# MAX32630 ERRATA SHEET

## Revision A2 Errata

#### 6) SPI MASTER INTERBYTE DELAY IN MODE 0

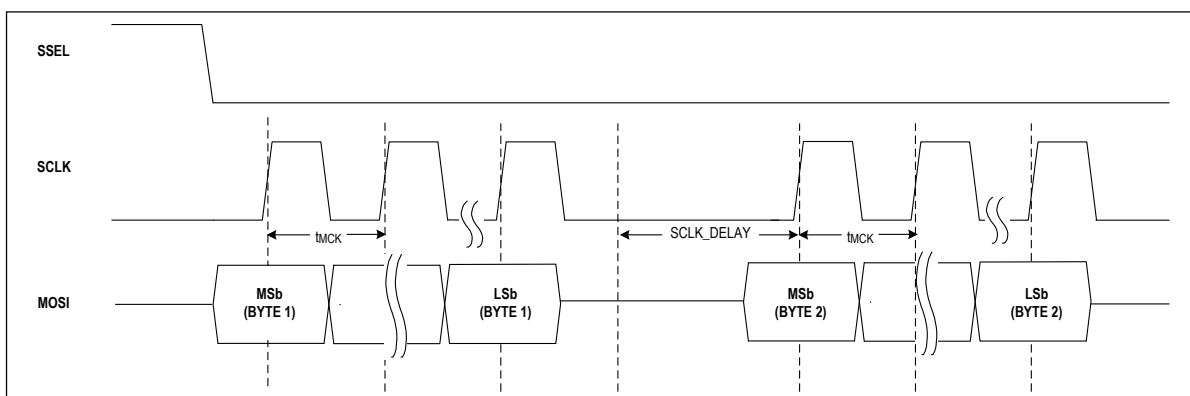
The SPI master remains low one or more SCLK cycles after transmitting 8 bits of data, resulting in an interbyte delay when transmitting back-to-back bytes. This erratum does not affect the integrity of the synchronous SPI bus because no data is clocked in or out by the SPI slave during the delay time SCLK is asserted low.

In single mode, the delay occurs after SDIO[0] has transmitted all 8 bits.

In dual mode, the delay occurs after SDIO[1:0] have each transmitted 4 bits.

In quad mode, the delay occurs after SDIO[3:0] have each transmitted 2 bits.

The length of the delay is a function of the SPI clock frequency as shown in the following table. The SPI master must be operated in sample mode with a maximum frequency of 24MHz.

None.
